STATE OF NORTH CAROLINA
DEPARTMENT OF TRANSPORTATION

DATE: June 18, 2026

SUBJECT: Roundabout Curb Details and Provisions

SAMPLE ROUNDABOUT TYPICAL SECTION

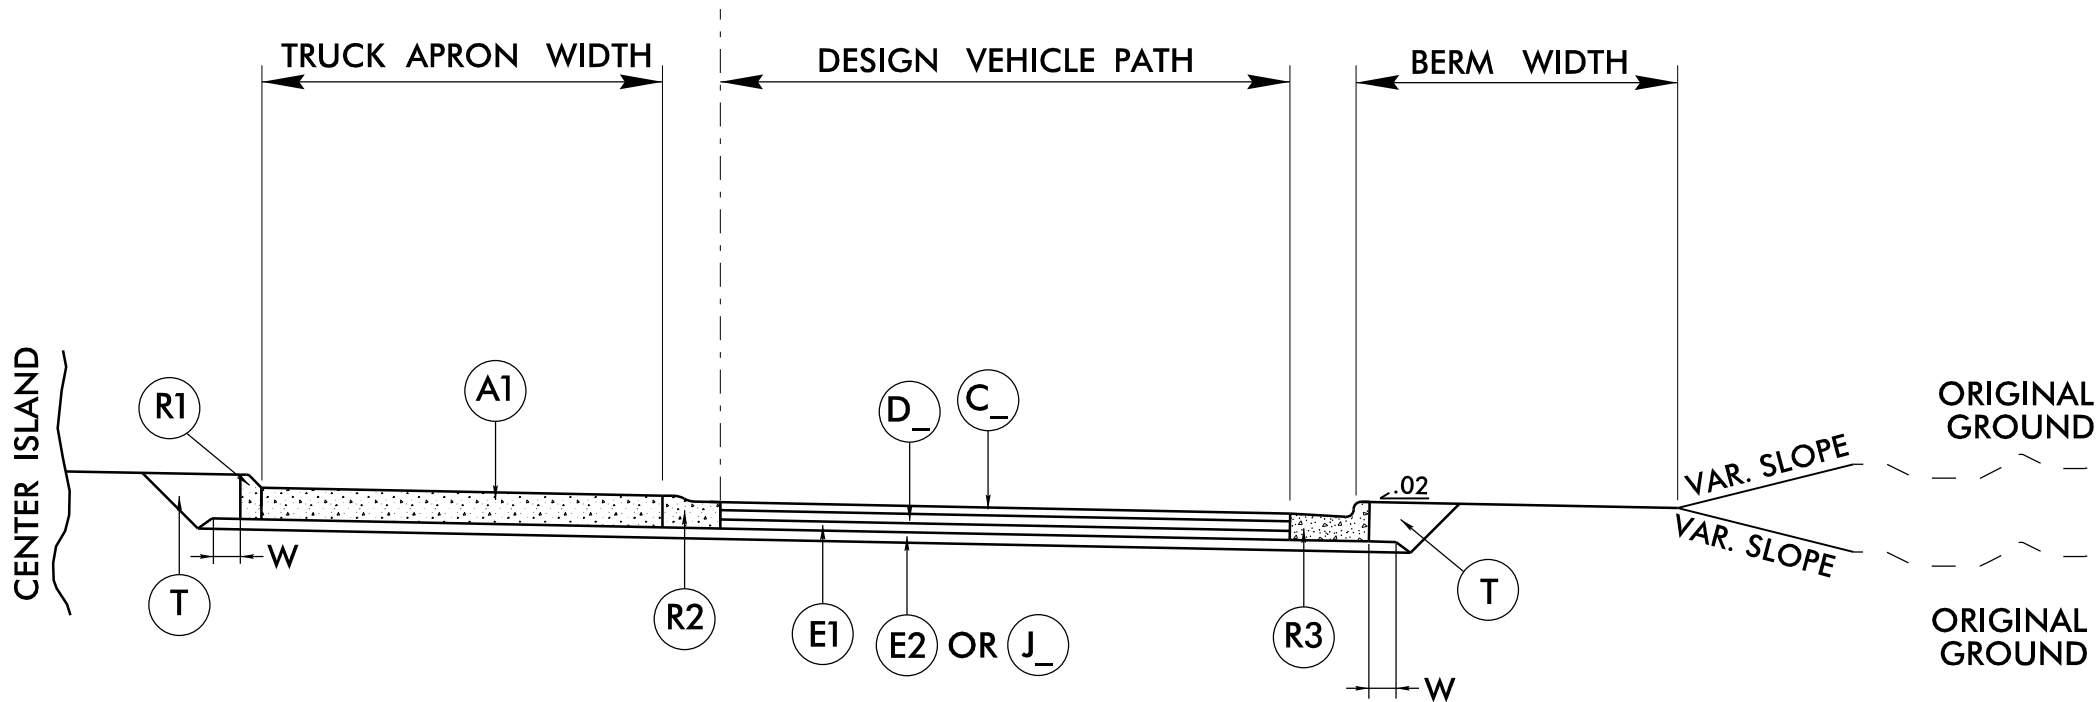
- The 3-inch rolled curb next to the truck apron is standard.
- A 2-inch rolled curb can alternately be used where a high percentage of low-clearance truck-trailer traffic is expected.
- The Curb and Gutter (Modified) detail is used in all cases to account for the increased pavement depth between curbs due to the 12-inch truck apron.
- Adding the roundabout typical section named "TYP – Roundabout Basic" from the roadway cell library to the roadway plans. See the attached roundabout typical section sample that follows the Roundabout Details for reference.

*WHEN CONCRETE TRUCK APRON IS LESS THAN 12", ADJUST THE 8" X 18" CURB BY REDUCING THE DEPTH ACCORDINGLY
